**Temporary Warehouse of Construction Materials and Associated Filling of Land
for a Period of Three Years in "Agriculture" ("AGR") Zone
at Lots 1016(Part), 1017, 1028S.A(Part), 1029(Part), 1030(Part), 1031, 1032, and
1033(Part) in DD 113, Kam Tin, Yuen Long, New Territories**

(Application No. A/YL-KTS/1130)

In response to the comments suggested by the Fire Services Department dated 3.6.2026, and the Lands Department dated 16.6.2026, we would like to submit herewith our responses for your consideration (Appendix A).

Responses to Departmental Comments

LAYOUT PLAN FOR FIRE SERVICE INSTALLATIONS (1:200)

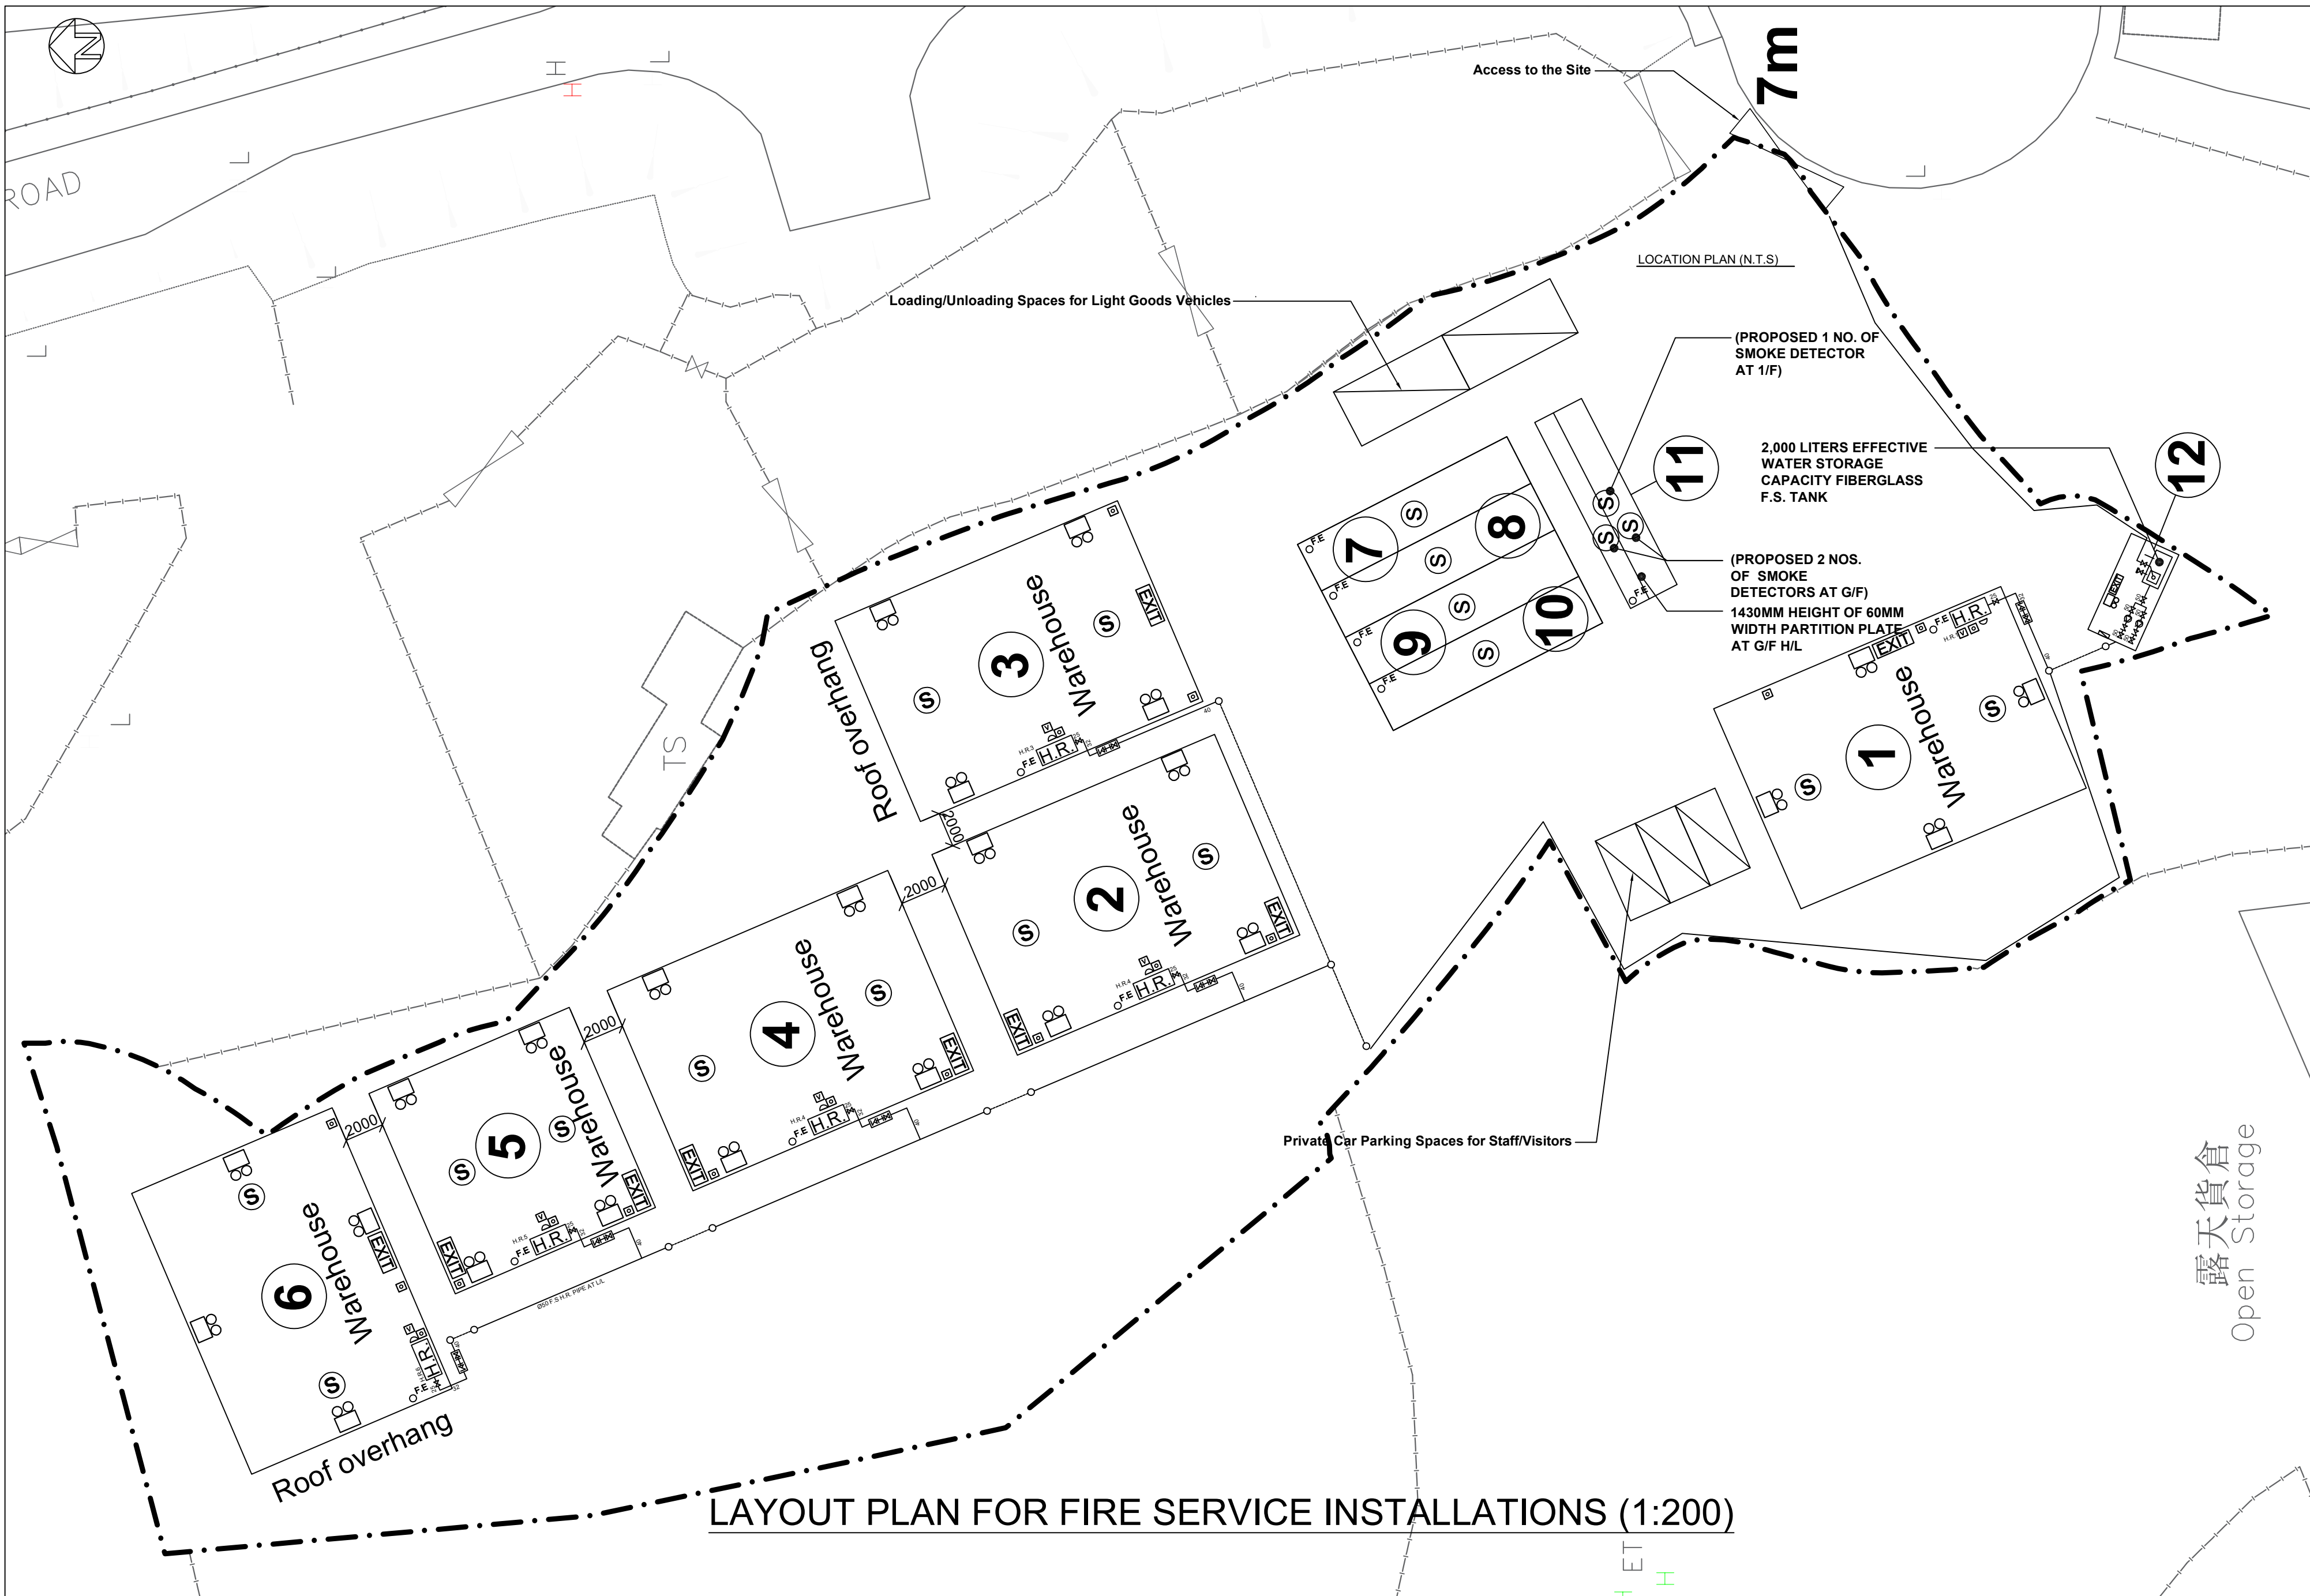
Departmental Comments		Responses
A.	Fire Services Department [Email dated 3.6.2026] (Contact Person: Mr. YUEN Tsz Fung, Tel: 2733 7781)	
	Based on the submitted FSI proposal, his comments are as follows: i. For enclosed structure with gross floor area not exceeding 230 m2, portable fire extinguisher and stand-alone fire detector shall be provided; ii. In relation to item (i) above, if two or more stand-alone fire detectors are installed in an enclosed structure, all detectors shall be interconnected (either wired or wirelessly) such that when one of the detectors is triggered, all connected detectors shall sound an alarm simultaneously; iii. Stand-alone fire detectors shall be provided in accordance with the “Stand-alone Fire Detector General Guidelines on Purchase, Installation & Maintenance [Sep 2021]”; iv. Separation distance between each structure shall be clearly indicated on the plan; v. In relation to item (iv) above, structures on the same site are regarded as adjoining structures if they are less than 1.8 m apart. In this regard, sprinkler system, wheeled type dry chemical fire extinguisher, stand-alone fire detector, emergency lighting and directional & exit signs shall be provided if the total floor area exceeds 230 m2; vi. Provision of FSIs shall be demonstrated in form of FS Notes with all relevant standards and specifications; vii. Modified hose reel system, fire alarm system, emergency lighting, directional and exit signs are considered as self-upgrades and are not mandatory requirements of this Department; viii. If the applicant self-initiates the provision of a modified hose reel system, the standard and specification shall be provided in accordance with the “Codes of Practice for Minimum Fire Service Installations and Equipment and Inspection, Testing and Maintenance of Installations and Equipment [September 2022 revision]”;	Please refer to the revised FSIs proposal. The Applicant will provide FSIs facilities to satisfy the requirements of the Fire Services Department accordingly.

ix. If the applicant self-initiates the provision of a fire alarm system, the standards and specification shall be in accordance with “BS 5839-1:2017 and the FSD Circular Letter No. 6/2021”; x. If the applicant self-initiates the provision of emergency lightings, the standards and specification shall be in accordance with “BS 5266-1:2016, BS EN 1838:2013 and the FSD Circular Letter No. 4/2021”; xi. If the applicant self-initiates the provision of directional and exit signs, the standards and specification shall be in accordance with “BS 5266-1:2016 and the FSD Circular Letter No. 5/2008”; and xii. Schematic drawings are not required to be submitted for vetting.
